UNITED STATES PATENT AND TRADEMARK OFFICE

10/582,700

| Office Action Summary | Application No. 10/582,700 | Applicant(s) EICHHOLZ ET AL. | |

DETAILED ACTION

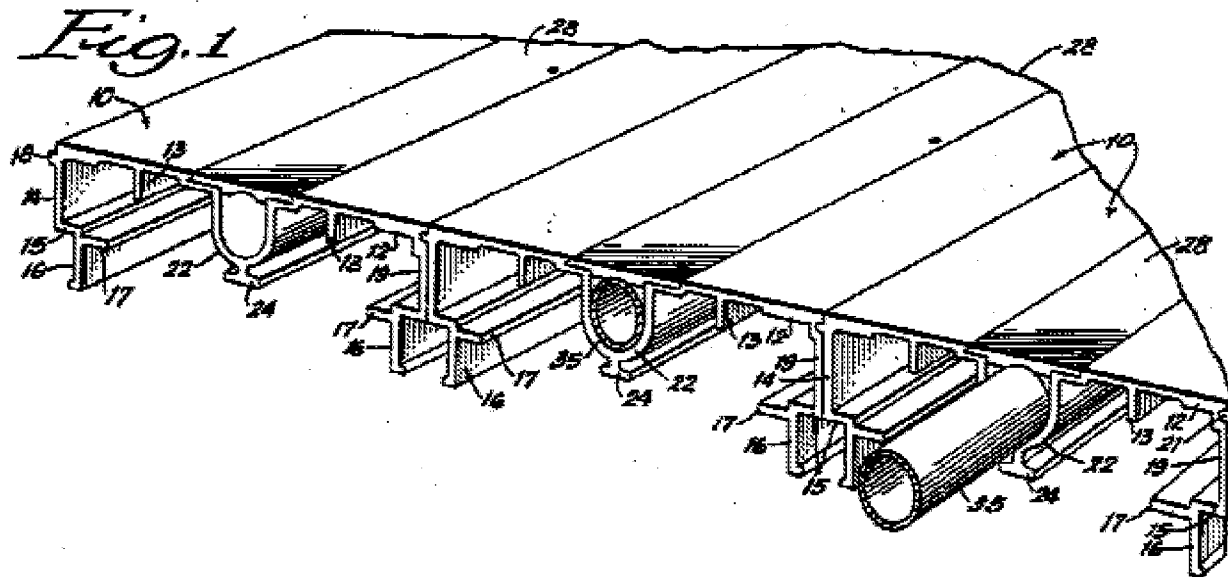
Claims 1-2, 4, 9, 14-15 are rejected under 35 U.S.C. 102(b) as being anticipated by US 2,799,481 (Becker).

Claim 1: Becker teaches floor heating, comprising:

a floor (fig. 1) made up of heatable panels (units 10, fig 1), characterized in that the panels have running through them first hollow chambers (22, fig. 1) and a feed line

(column 3 lines 22-24) connected to the first hollow chambers (16, fig. 2) for warm waste air which originates from the cooling of the aircraft's electronic equipment. While the panels disclosed are not taught for use in an aircraft or for "waste air which originates from the cooling of the aircraft's electronic equipment," they are disclosed for steam and are considered capable of being heated by waste air from an aircraft's electronic equipment.

Claim 2: Becker teaches floor heating in accordance with claim 1, characterized in that the first hollow chambers (22) extend in the longitudinal direction of the aircraft inside the panels (column 3, lines 5-6).

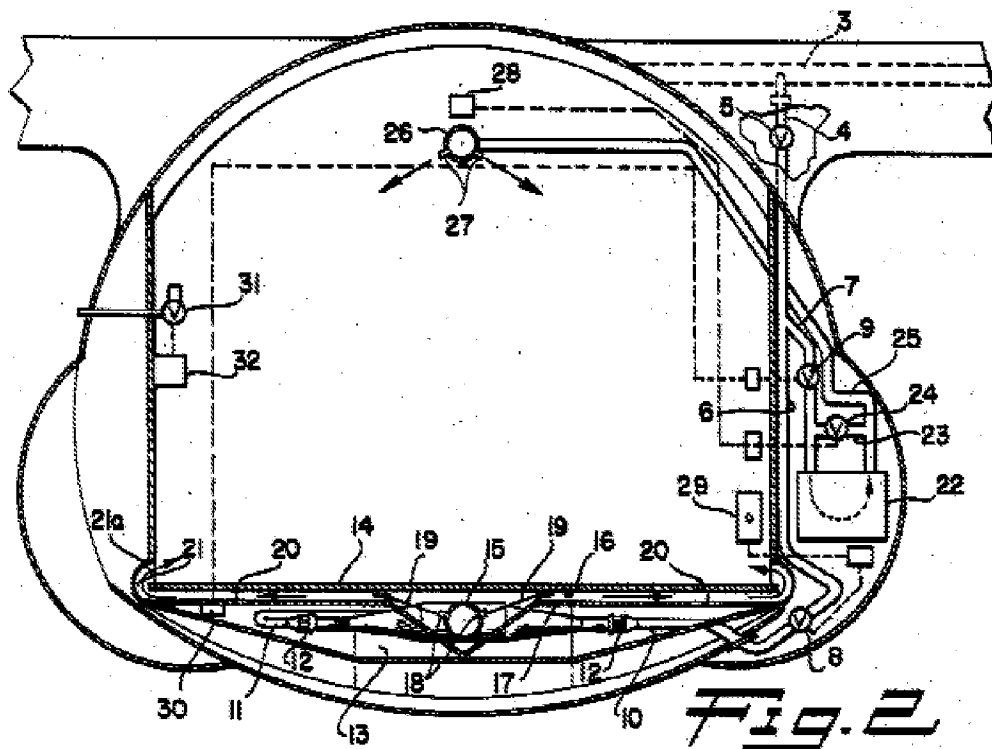
Claims 1, 2, and 13 are rejected under 35 U.S.C. 102(b) as being anticipated by US 3,203,473 (Goode).

Claim 1: Goode teaches floor heating for an aircraft, comprising a floor (14, fig. 2) made up of a heatable floor, characterized in that the floor has running through it first hollow chambers (16, fig. 2) and a feed line (6, fig. 2) connected to the first hollow chambers for warm waste air which originates from the cooling of the aircraft's electronic equipment. Though Goode does not disclose individual panels the entire floor can be considered as a panel, which is considered heatable. Goode does disclose hollow chambers (16, fig. 2) in the floor (14) through which hot air is fed by duct 6 (col. 2, lines 60-64), which can be considered a feed line.

Claim 2: Goode teaches floor heating in accordance with claim 1, characterized in that the first hollow chambers extend in the longitudinal direction of the aircraft inside the panels (better seen in fig. 1, but clear when seen that fig. 2 is a cross section that the spaces 16 extend longitudinally).

Claim 13: Goode teaches floor heating in accordance with claim 1, characterized in that ventilators (jet pump 12) are positioned in the hollow chambers in order to generate a forced flow through the hollow chambers. The jet pumps disclosed are considered capable of generating a forced flow through the hollow chambers, and are disclosed to be located in the hollow space of the floor.

FIG. 2

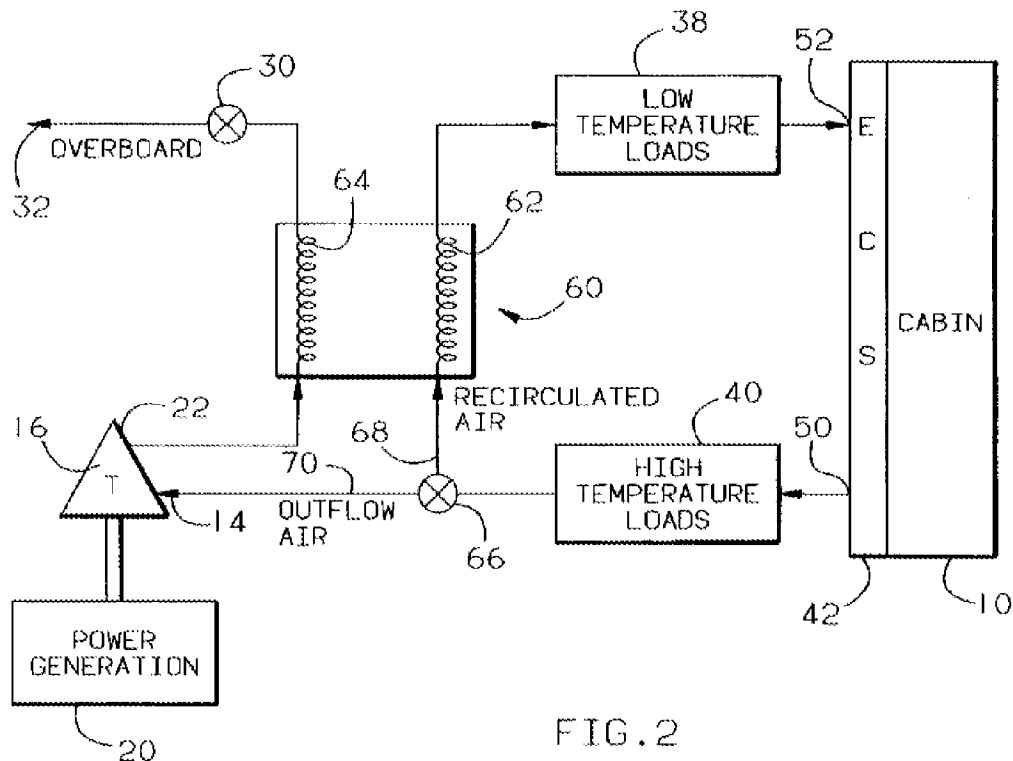
Severson teaches a low temperature load (38, fig. 2) which may comprise sensitive electronics such as avionics (col. 2, line 56), which, when cooled, dumps the waste air into the cabin of the aircraft through a port (52, fig. 2). Though Severson does not teach the use of the hot waste air to heat the floor of the aircraft, the floor panels disclosed by Becker require a heating medium and it would have been considered obvious to one of ordinary skill in the art to use the hot air from Severson in the panels of Becker for the purposes of heating the floor.

Severson teaches heating exhausts the air from second hollow chambers into electronics bays (item 40, fig. 2 Severson) which are considered to be a part of the fuselage. It would have been obvious to a person of ordinary skill in the art at the time of the invention to exhaust the air run through the panels of Becker into the fuselage of the plane as in Severson for the purposes of cooling high temperature electronics (col. 2, lines 50-53)

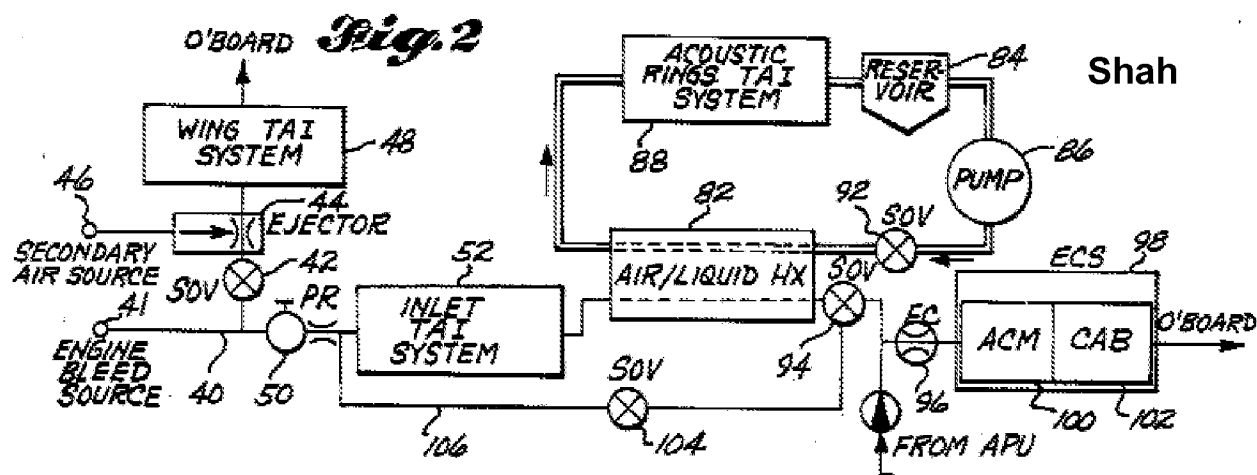
It is not novel to mix air flows to reach a desired temperature; Monfraix teaches a method of hot air supply wherein hot bleed air is mixed with cold ram air, both with feed lines, to heat an aircraft to a desired temperature.

The feed line cross section is considered to determine the amount of hot engine bleed air supplied.
